Revised SSA Work Plan Addendum for Additional Phase III Activities at Gabriel Manufacturing Co., Inc.

DATE: October 13, 2008

Figure 3
Proposed Overburden (Till) Monitor Well Location
Supplemental Site Assessment
Gabriel Manufacturing Co. Inc.

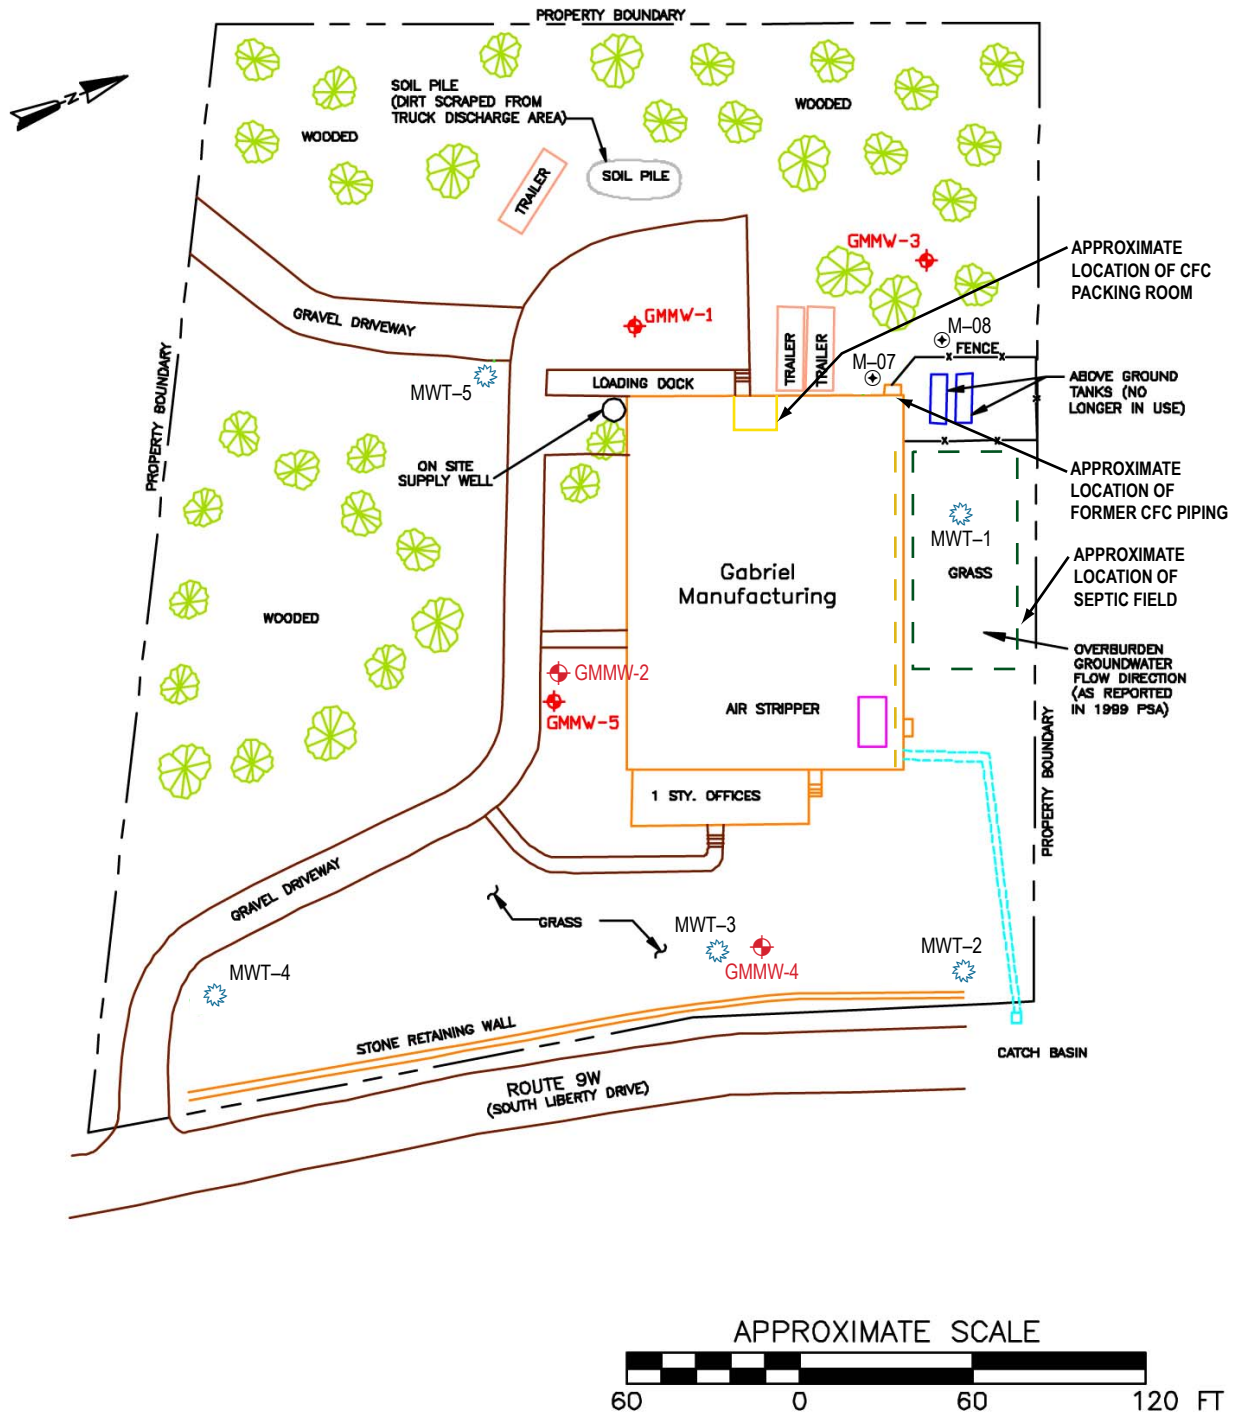
NYSDEC comments received via e-mail on August 11, 2008, requested that one additional overburden well be installed at the site in the location of the septic field. CH2M HILL reviewed the MIP detector responses based on the NYSDEC request and noticed the following:

- MIP boring locations M-07 and M-08 were installed adjacent to the aboveground tanks at the site, and MIP location M-07 was installed in the proposed location of monitoring well MWT-1. Review of the MIP information down to 8 feet, however, indicates no ECD responses in either sample location M-07 or M-08. These responses appear to indicate that surficial release in this area did not occur.
- Based on the MIP ECD response, the detector responses generated from the septic field MIP work are one to two orders of magnitude greater than ECD responses at MIP locations M-07 and M-08.

Based on this information, CH2M HILL proposes that monitoring well MWT-1 be relocated to the septic field area. Figure 3 indicates MIP locations M-07 and M-08 as well as the newly proposed location for overburden monitor well MWT-1 installation locations.
